PMD Link Training issues

Jeff Slavick

21 June, 2017

Figure 136-7—PMD control state diagram

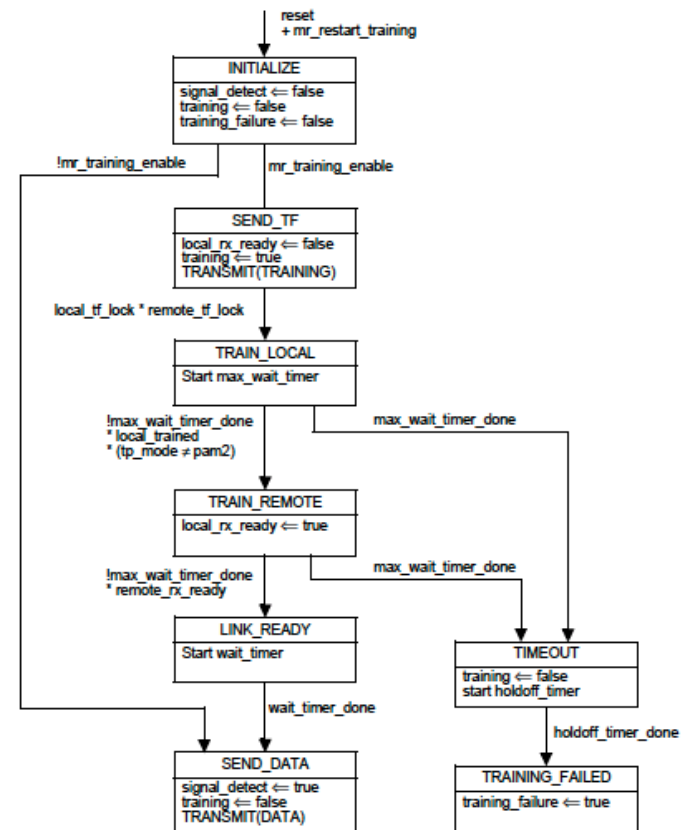
- Local_rx_ready is updated in training FSM. But ENCODE_STS is not called by that FSM. So there's no locally initiated process to update the transmitted Status field when local_rx_ready asserts.

Figure 136-9—Coefficient update state diagram

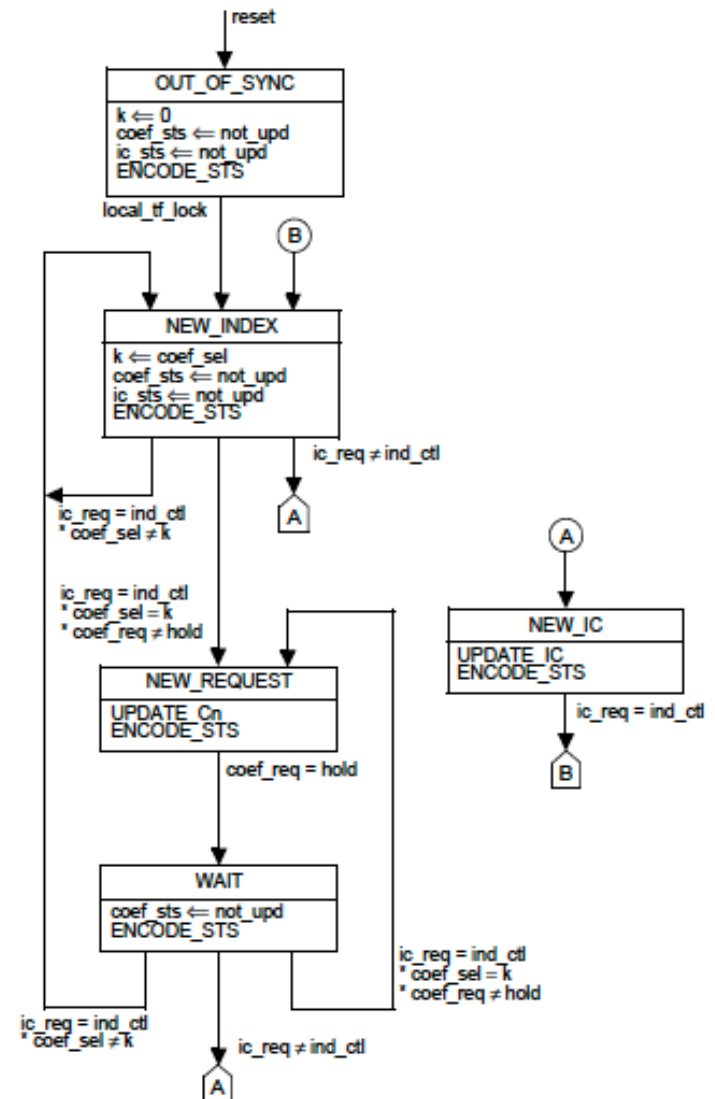
- ENCODE_STS
 - Encodes portions of the status field of transmitted training frames.
~~local_tf_lock is mapped to the receiver frame lock bit, k is mapped to the coefficient select echo bits, coef_sts is mapped to the coefficient status bits, ic_sts is mapped to the initial condition status bit, local_rx_ready is mapped to the receiver ready bit, and tp_mode is mapped to modulation and precoding bits (see 136.8.11.3.2).~~
- ENCODE_STS updates stuff that is changed by the COEFF UPDATE FSM

Figure 136-9—Coefficient update state diagram

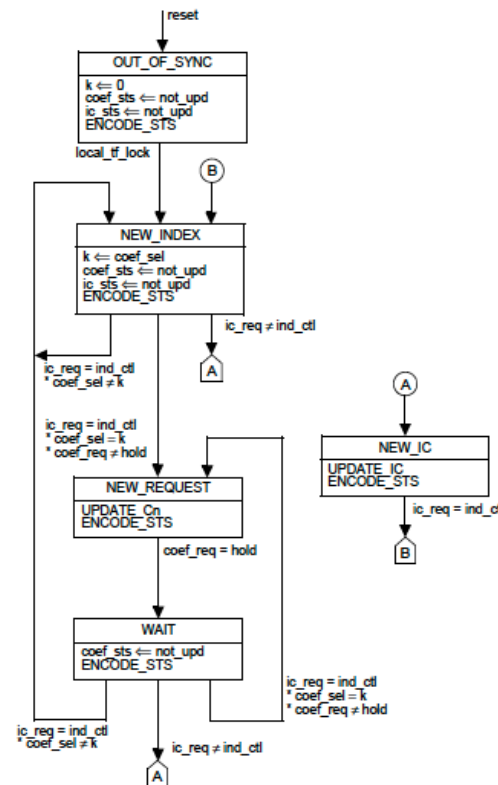
- Add “+ mr_restart_training” to both Figure 136-8 and 136-9
 - This aligns with how CI72 acts and forces all FSMs to reset when mr_resart_training asserts appropriately since a reset may not occur.
